Comments to: 100 AVENUE ROAD (THEATRE SQUARE) DRAFT CMP
– CONSULTATION STATEMENT – 05/12/17. Ref: [2017/6638/CMP](#)

30/01/18

**Comparison of Camden Council's Neighbour details for Planning Application - 2014/1617/P.
and EL's Catchment Area for CMP - 100 Avenue Road London NW3 3HF**

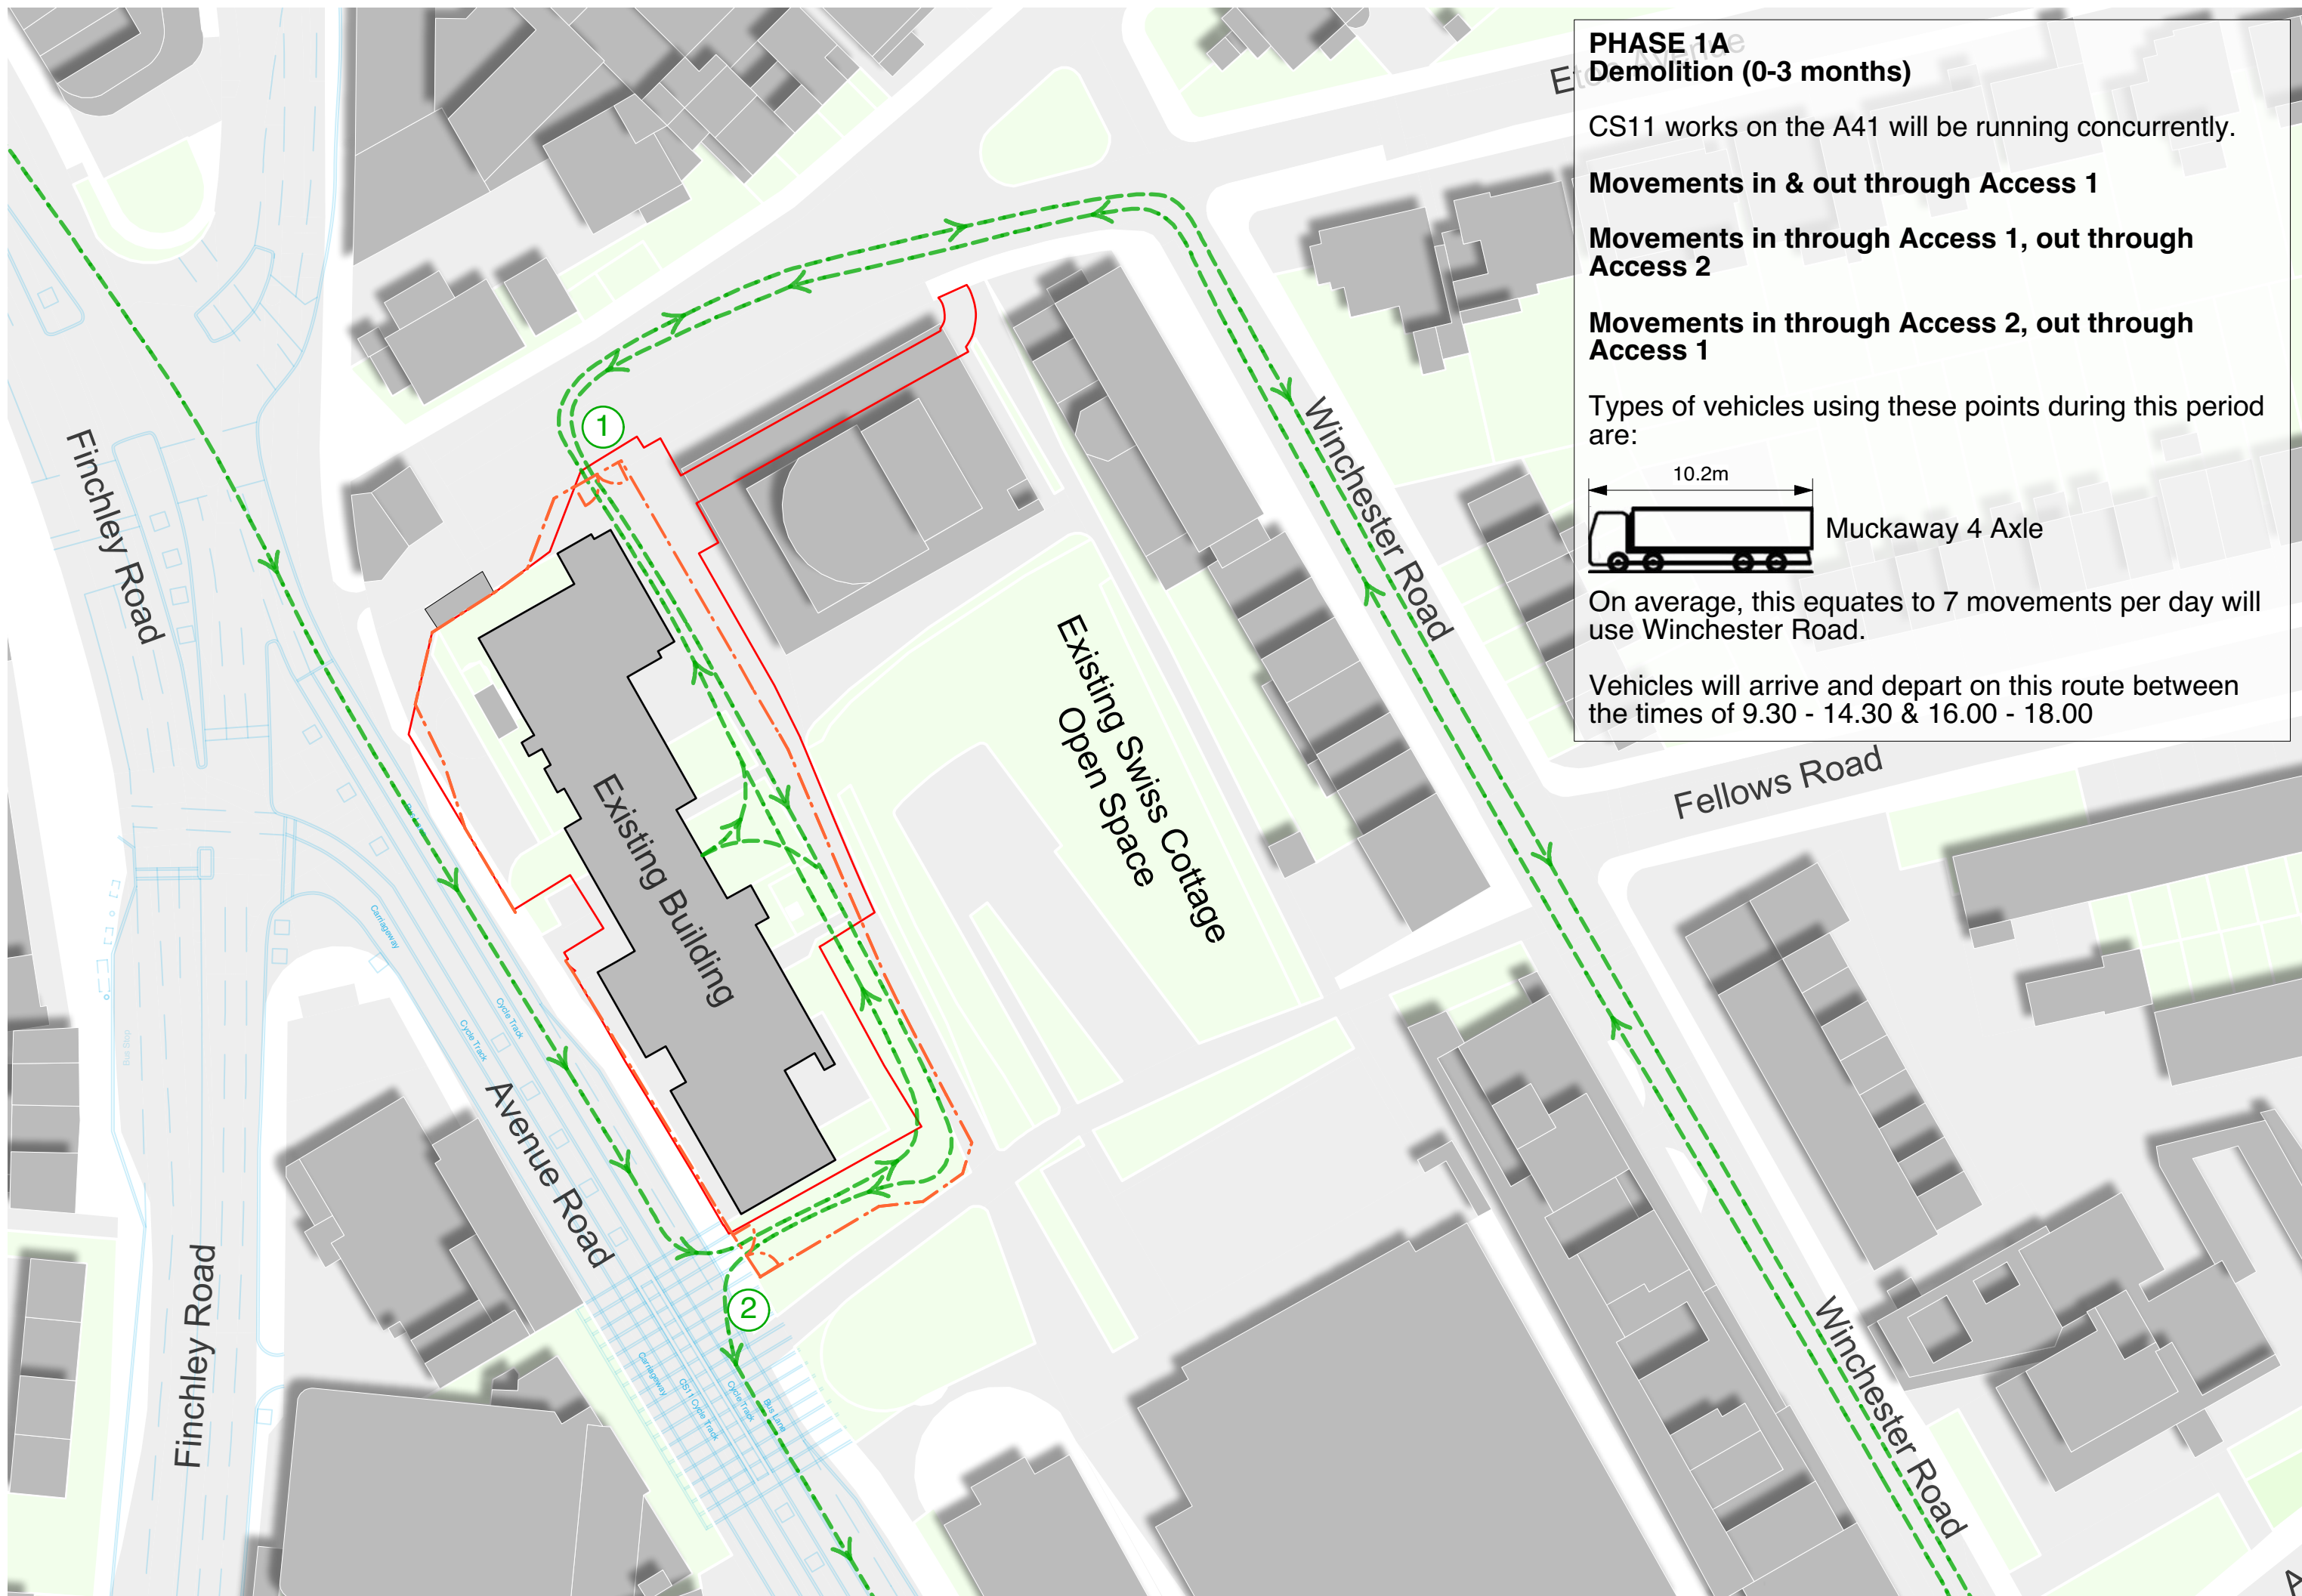
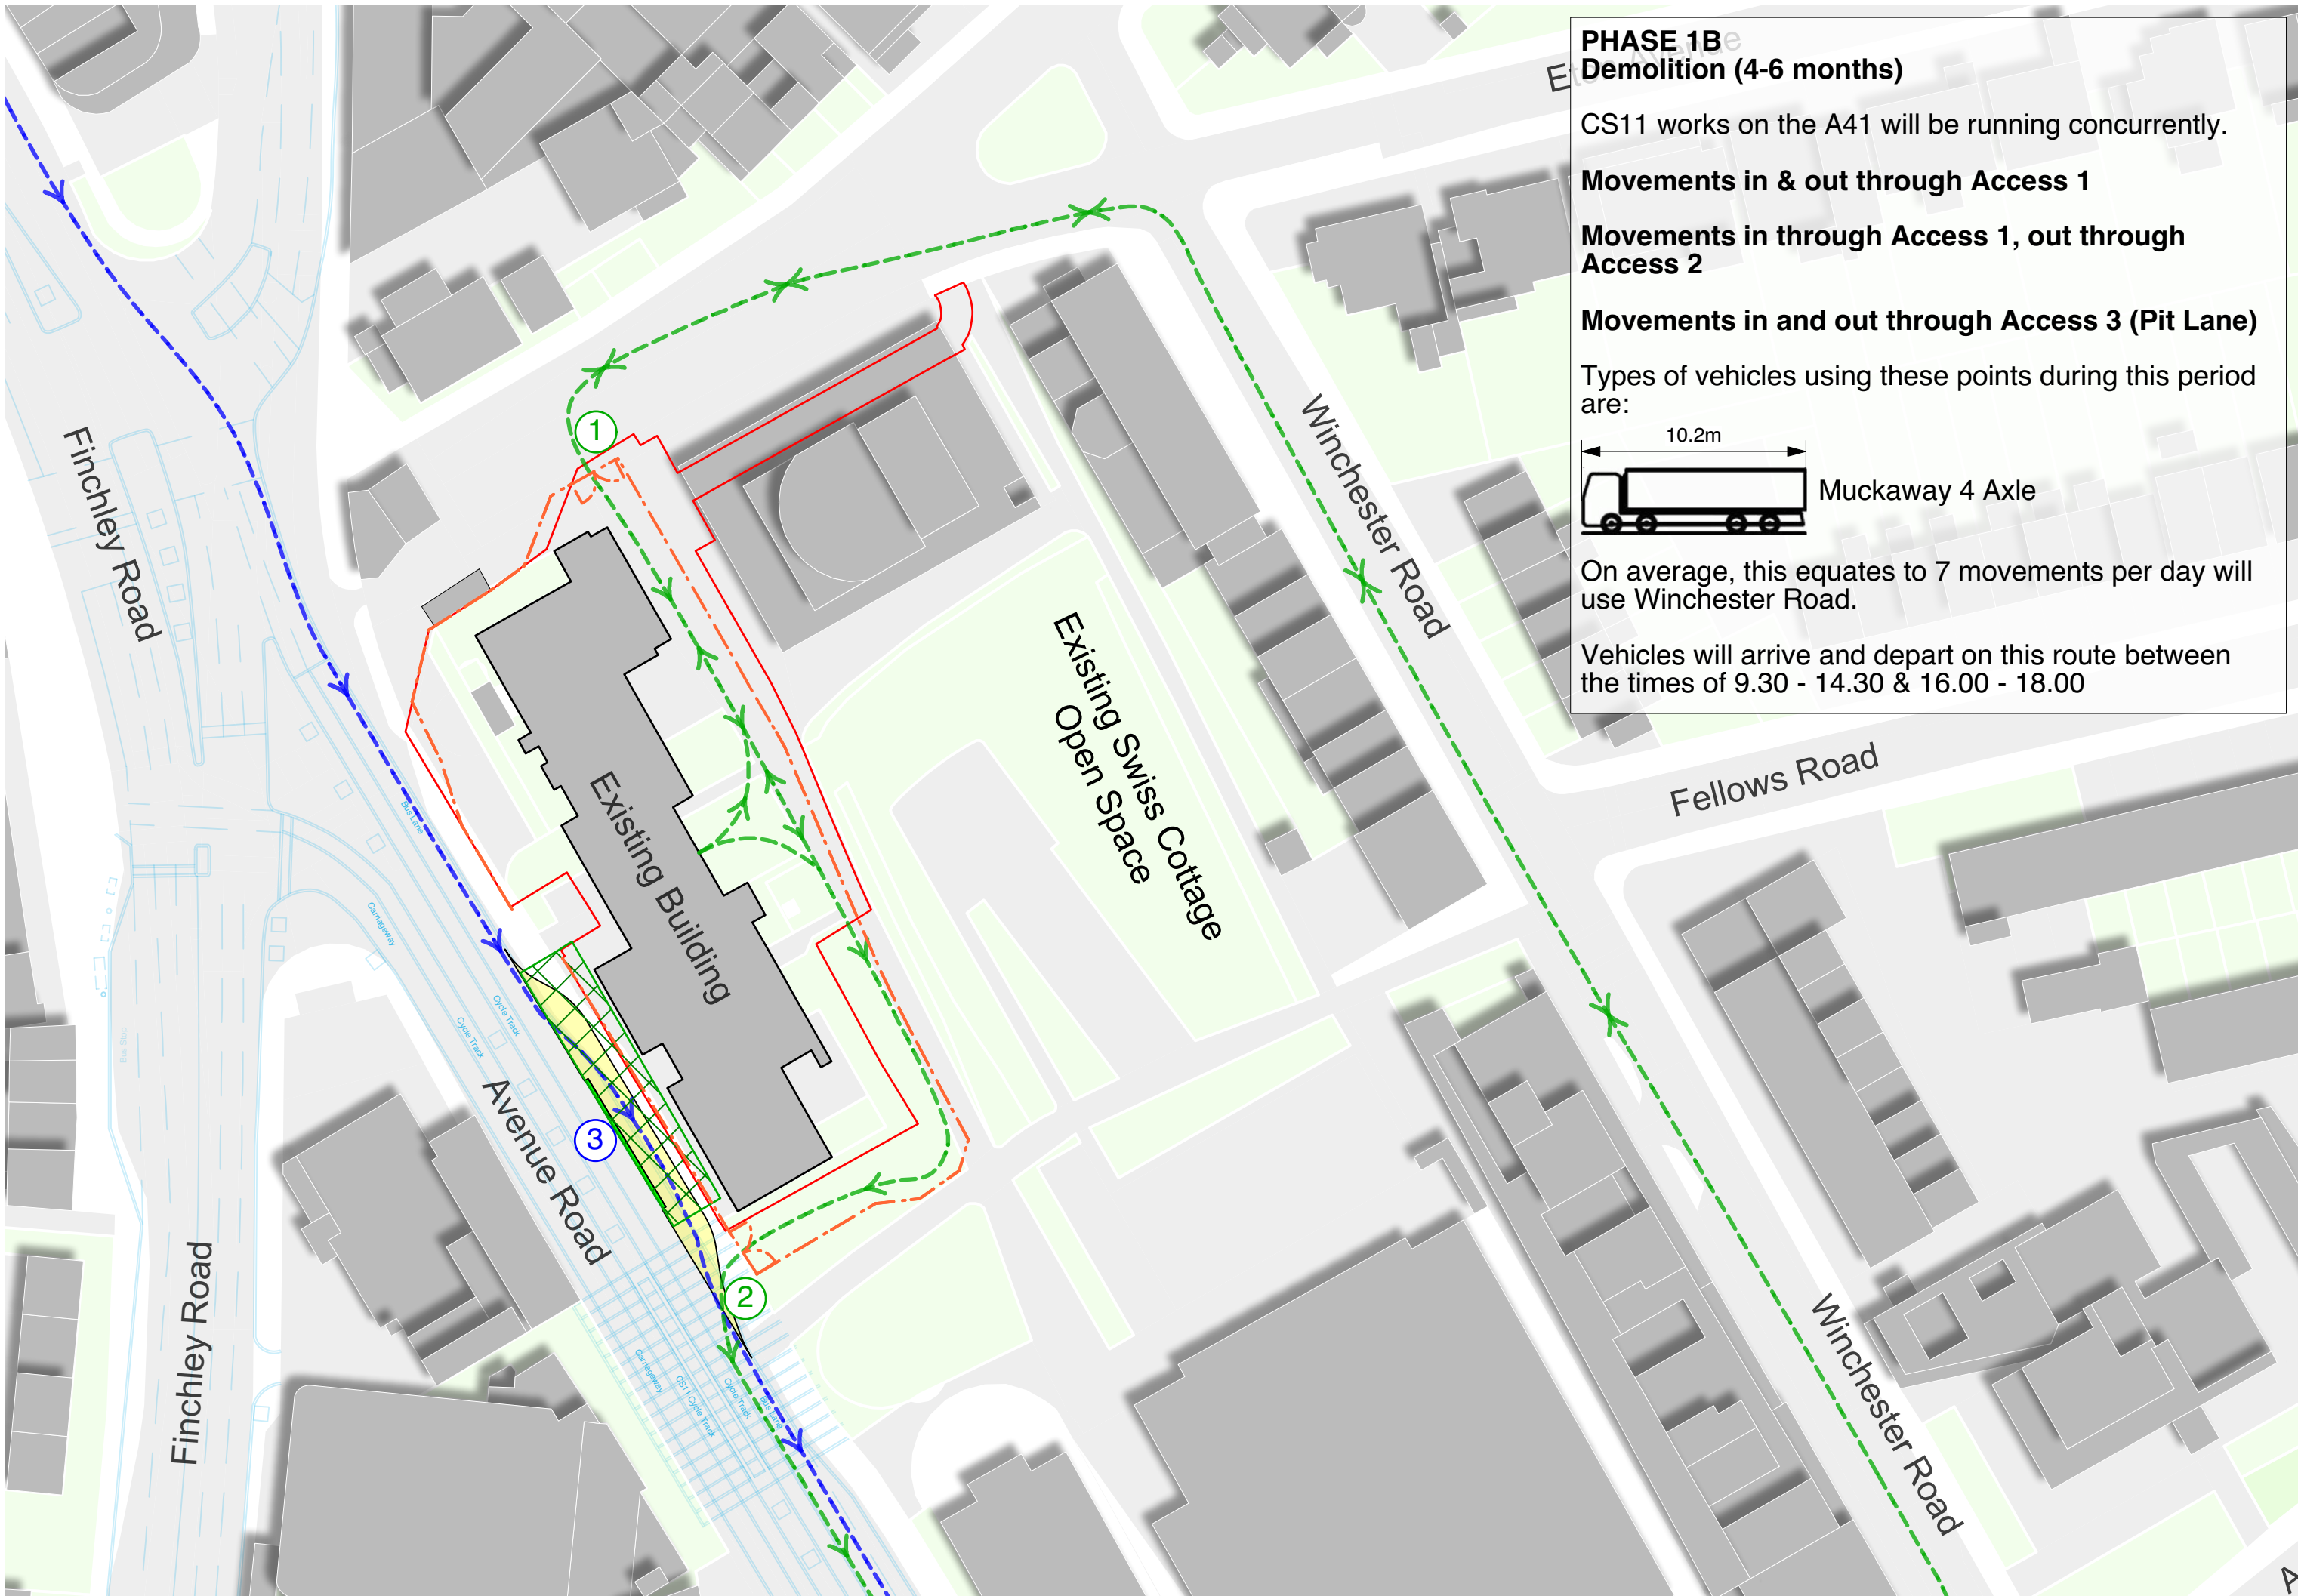
- 2.7. Yet Principle Planning Officer Jonathan McClue informs us in his email [19/12/17] that: *"it was suggested that EL consult as per the original planning application as a minimum. The (EL) map.... was not produced by the Council."* Please compare

Camden's catchment area with EL's, and a list of all the streets that were notified about the original application 2014/1617/P. Note that Camden's Catchment area is more than 3 times the size of EL's. [\[See Appendix 1\]](#)
